STAFF ANALYSIS

Case No.: CZ-20-1243619 **Agenda #:** N. 7

Location/Address: 1816 Candler Road **Commission District:** 03 **Super District:** 07

Request: A major modification to remove zoning conditions CZ-89033, CZ-90052, and CZ-91039 to allow for mixed use development, Candler Crossing, in the Interstate 20 Corridor Compatible Use Overlay District.

By: 
Printed Name: Michele L. Battle

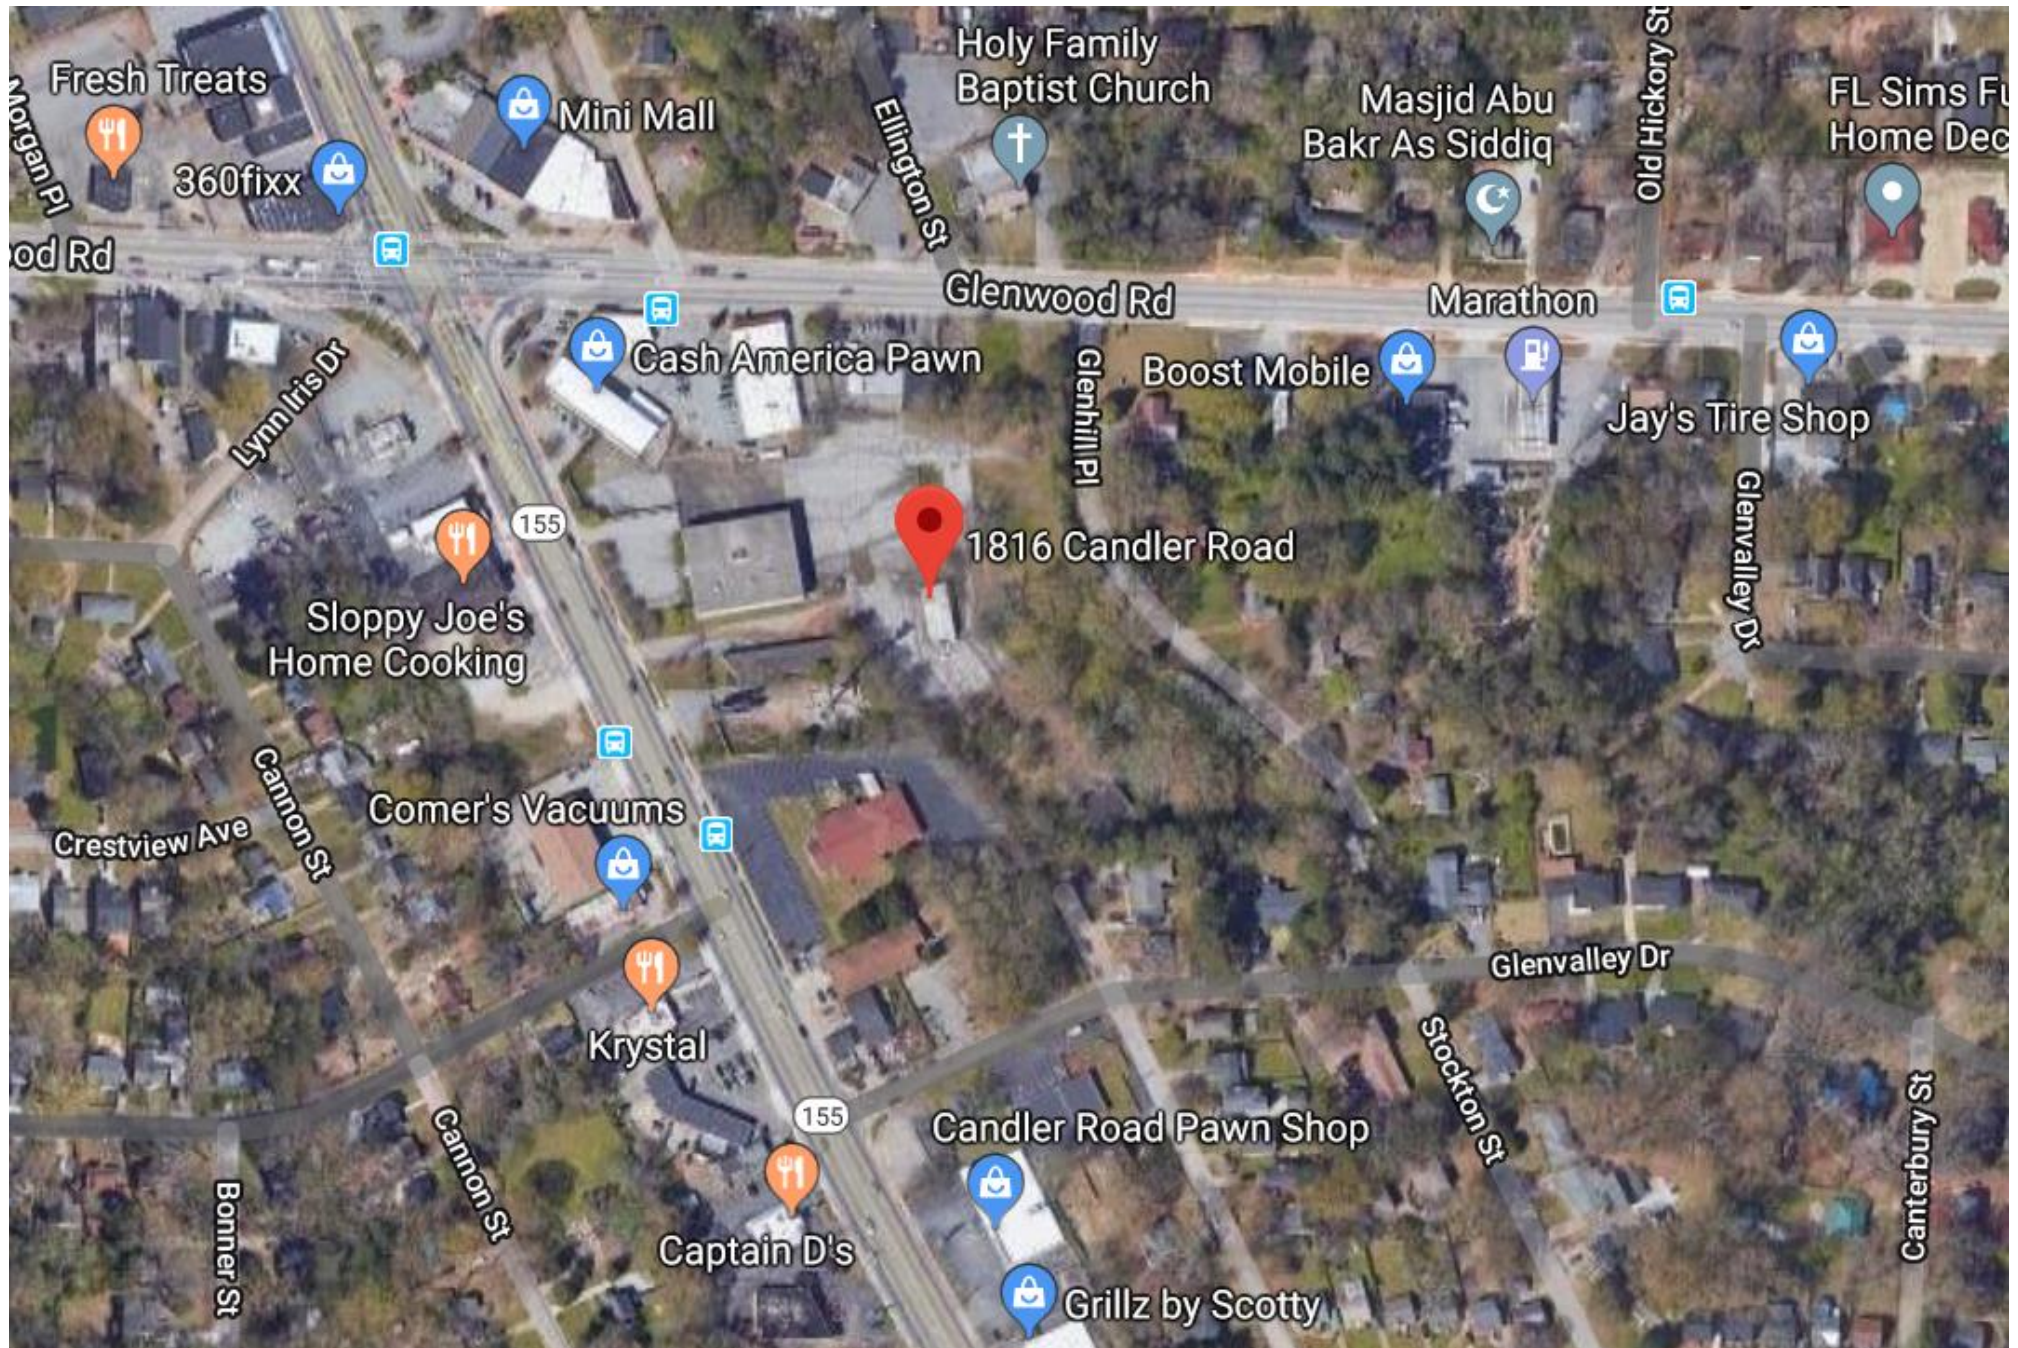
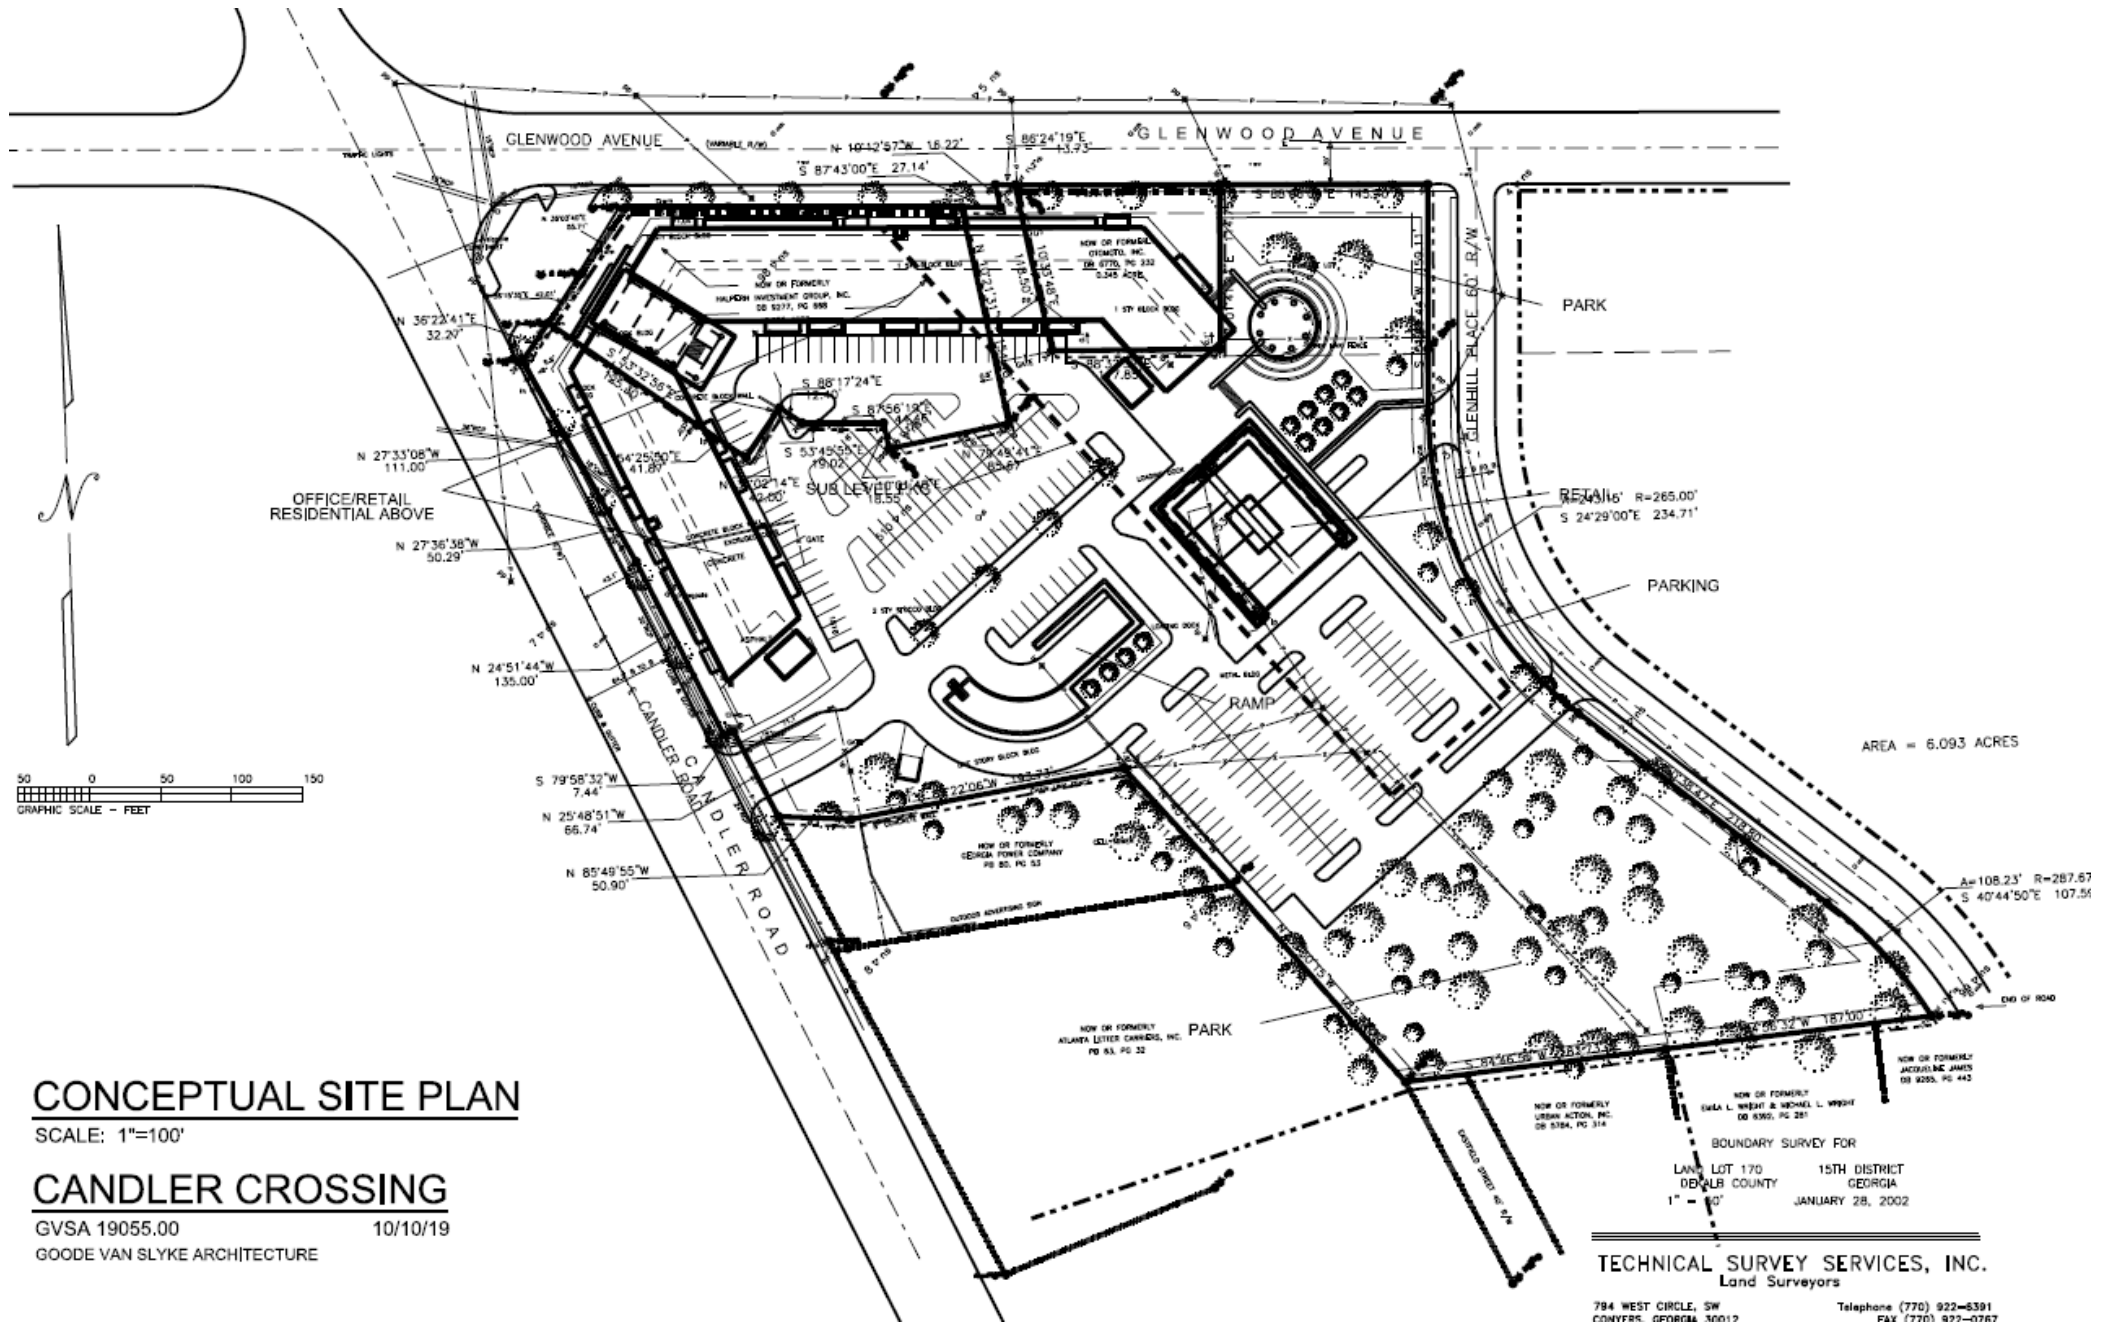
ASSTO guidelines must be submitted with permitting. Per the submitted site plan, access is proposed on Glenhill Place.

The DeKalb County Planning and Sustainability Department – Land Development Division provided the following comments: Stormwater management is required per Chapter 14-40; A hydrology report with a detention pond. The submitted sketch does not show detention pond or indicate if it is underground. The volume generated by this new development will require a dedicated lane into or possible exiting the development to the intersection.

Storm water management is required as per Chapter 14-40, over 5000 square feet of impervious.

The report shall have a Hydro report with a detention pond. The sketch submitted shows no detention pond, or indicated if it is underground.

The Volume of traffic generated by this new development will require a dedicated lane into or possible exiting the development to the intersection.

1. Must comply with the Interstate 20 Corridor Compatible Use Overlay District with plans that show building setbacks, height of building and structures, density, density bonus (if applicable), required parking, open space calculations, transitional buffer zone and transitional height, elevations complying with architectural regulations and landscaping requirements. Variances may be obtained from appropriate regulatory authorities.
2. Access to and from Glenhill Place shall be prohibited.
